VKPC 86450

Technical Bulletin – February 2015

RENAULT Espace IV, Vel Satis (3.0 Dci)
Opel/Vauxhall Vectra C/Mk II, Signum (3.0 V6 CDTI)
Saab 9-5 (3.0 TiD)

SKF adjustment to gasket material content

Advices for waterpump replacement

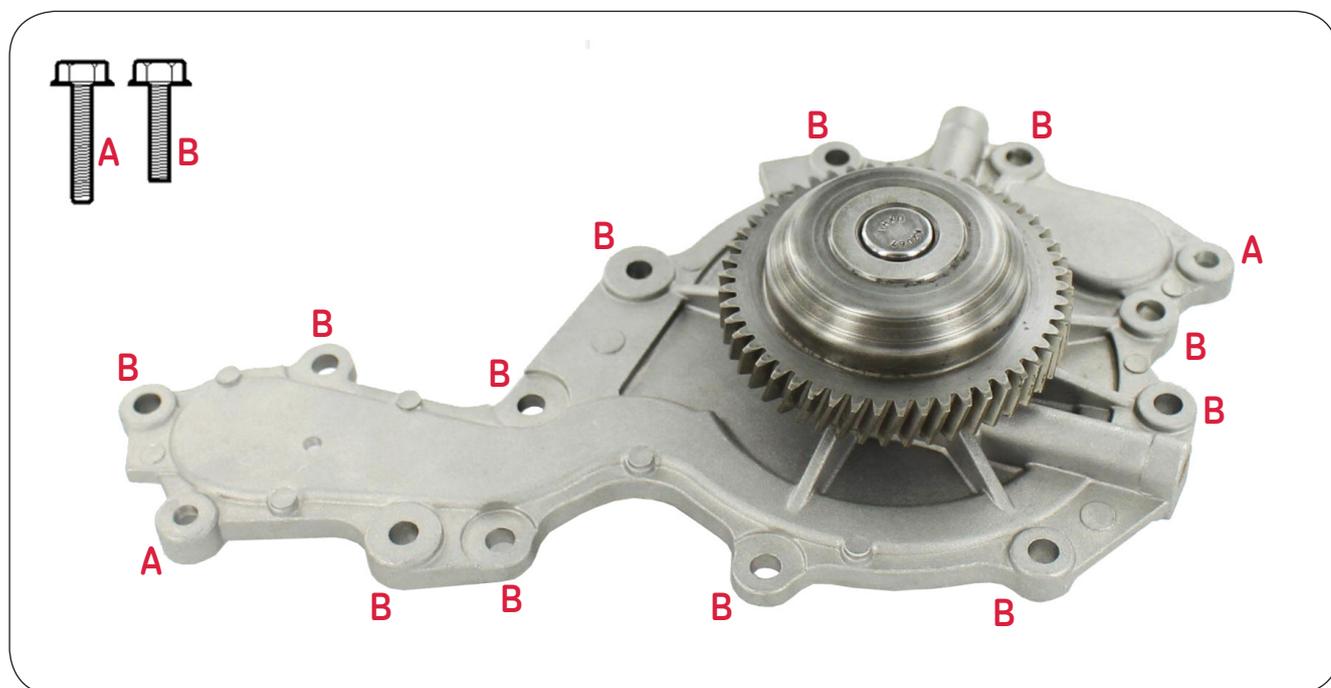
Pay attention not to mix bolts (A) + (B) during their mounting as it could lead to cooling leakage in the oil sump. Beware the leakage cannot be observed after remounting the sealed timing gear cover.

Note! Please note the importance of the appropriate bolt lengths and used them in correct locations along with torque, as possible leakage can occur if mounting process is not followed correctly.

Bolt tightening torque:

A longer bolts = 11 Nm

B shorter bolts = 11 Nm
